REVISED (JANUARY 2004)
**TOTAL MAXIMUM DAILY LOAD FOR TURBIDITY, STREAM
 BOTTOM DEPOSITS, AND TOTAL PHOSPHORUS**
 In the Canadian River Basin (Cimarron)

NOTE: This TMDL was originally approved in September 1999. The TMDL was revised in 2004 to include a waste load allocation for the proposed Village of Angel Fire Wastewater Treatment Plant (WWTP).

Appendix G: Response to Comments

In response to the Draft Total Maximum Daily Loading document for the Canadian River Basin, issued June 8, 1999, the Carson National Forest would like to offer the following comments.

Figure 1:

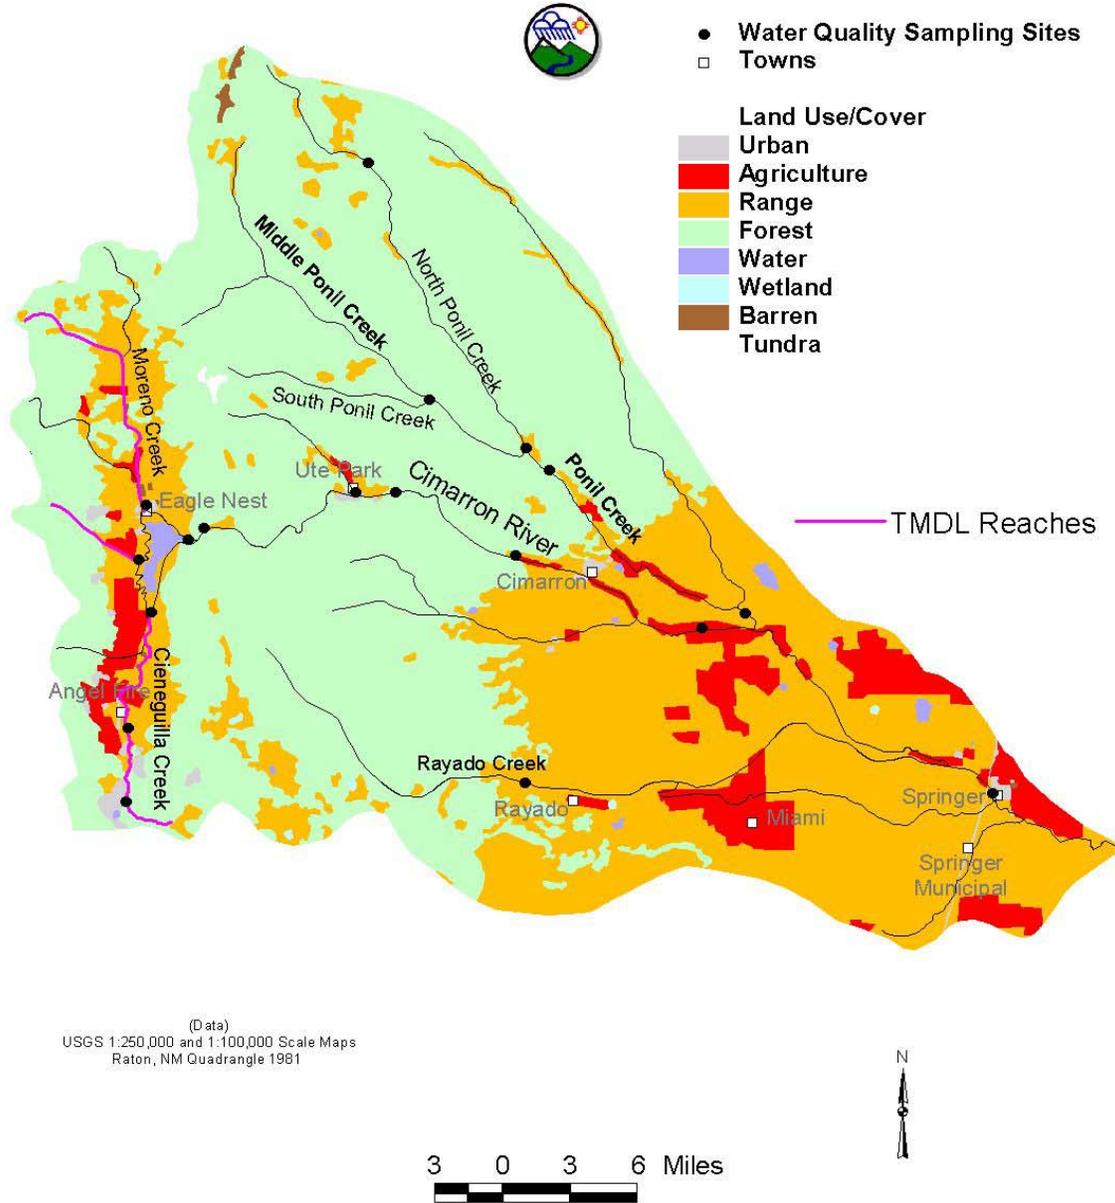
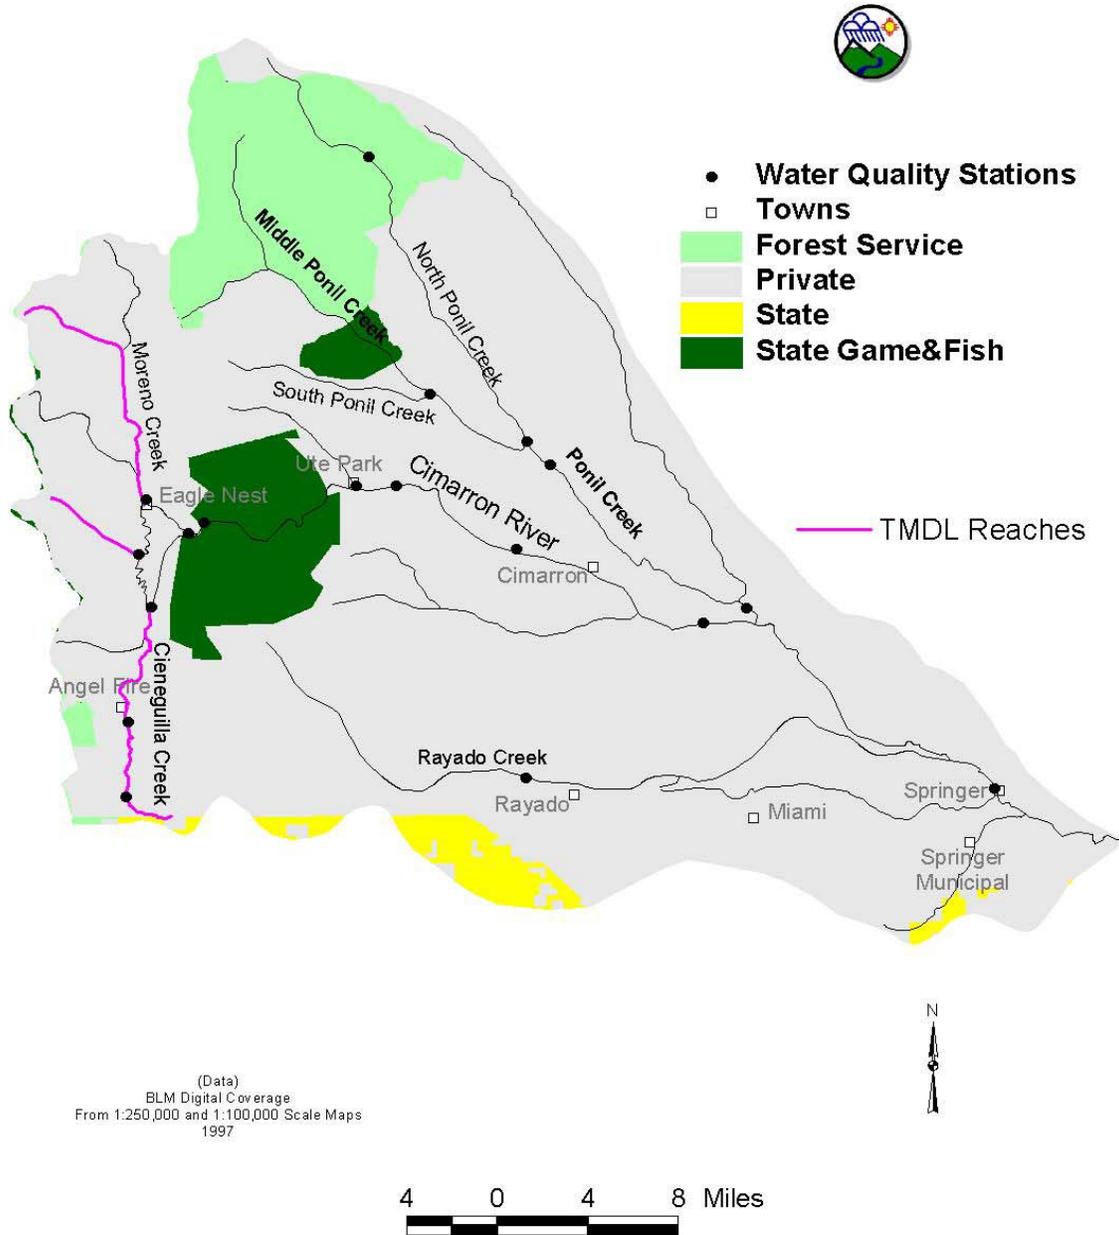
C Land use/cover and Cimarron (sic) watershed Figures (1 and 2) - these two figures display various types of information without citation as to the source of the information (ie - land cover and use Southern Rockies - Eco #210, etc.). Also, Figure 1 displays "TMDL segments" with a bold line type indicating various stream segments of interest but Figure 2 does not display the same stream segments with this bold line type in all cases. This is confusing from the standpoint of what these two figures are intended to display or not display.

R The two figures have been updated to address your concern. Both figures now show the Impaired Reaches (in pink) that are being addressed in this document.
